Subject: Exelon Generation Company, LLC (EGC), Response to Requests for Additional Information (RAI) regarding the Environmental Portion of the Application for an Early Site Permit (ESP) (TAC NO. MC1125)

Re: Letter, U.S. Nuclear Regulatory Commission (T. J. Kenyon) to Exelon Generation Company, LLC, (M. Kray), dated August 23, 2004, Request for Additional Information (RAI) Regarding the Environmental Portion of the Early Site Permit Application for the Exelon Generation Company Site (TAC NO. MC1125)

U.S. Nuclear Regulatory Commission
September 23, 2004, Enclosure 1

U.S. Nuclear Regulatory Commission
September 23, 2004, Enclosure 2

Insert new Figure 9.2-3, Illinois Wind Resource Map:

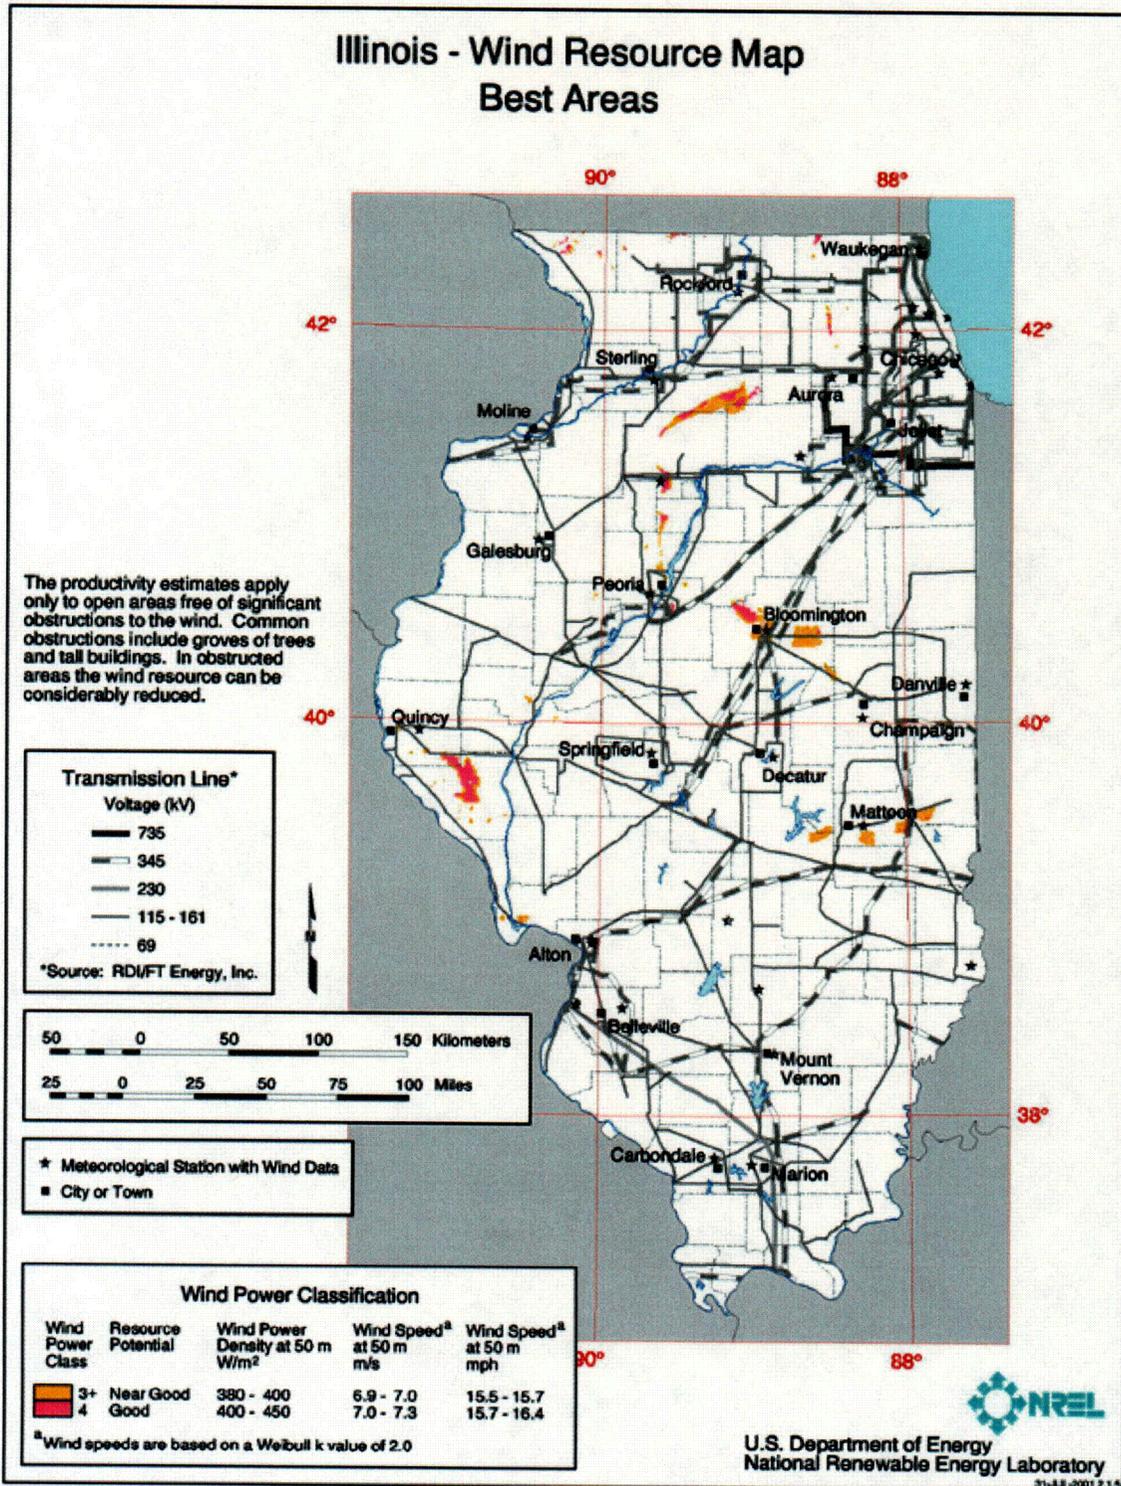
E9.2-1 In its August 6, 2004, Memorandum and Order, the Atomic Safety and Licensing Board for the Exelon early site permit application admitted the following contention:

CONTENTION: The Environmental Review fails to rigorously explore and objectively evaluate all reasonable alternatives. In Section 9.2 of the Environmental Report, Exelon claims to satisfy 10 CFR 51.45(b)(3), which requires a discussion of alternatives that is "sufficiently complete to aid the Commission in developing and exploring" "appropriate alternatives concerning alternative uses of available resource," pursuant to the National Environmental Policy Act. However, Exelon's analysis is premised on several material legal and factual flaws that lead it to improperly reject better, lower-cost, safer, and environmentally preferable wind power and solar power alternatives, and fails to address adequately a mix of these alternatives along with the gas-fired generation and "clean coal" resource alternatives. Therefore, Exelon's ER does not provide the basis for the rigorous exploration and objective evaluation of all reasonable alternatives to the ESP that is required by NEPA.

Provide information to address this contention.

EGC has addressed the issues raised in the Contention. As a result, ER, Chapter 9, Section 9.2.2.1, Wind, Section 9.2.2.4, Solar, Section 9.2.4, Conclusion, Table 9.2-6, Impacts Comparison Summary, Table 9.2-7, Impacts Comparison Detail, and References for Section 9.2 will be revised. Section 9.2.3.3, Combination, Figure 9.2-3, Illinois Wind Resource Map, and Figure 9.2-4, Direct Normal Solar Radiation Map will be inserted.

Wind resource maps usually identify areas by wind power class (See Figure 9.2-3). Although some midwestern states like North and South Dakota, as well as parts of Iowa, have excellent potential (Class 6 and above) for development of wind generation; the potential for generation is more intermittent in Illinois (ELPC, 2001).
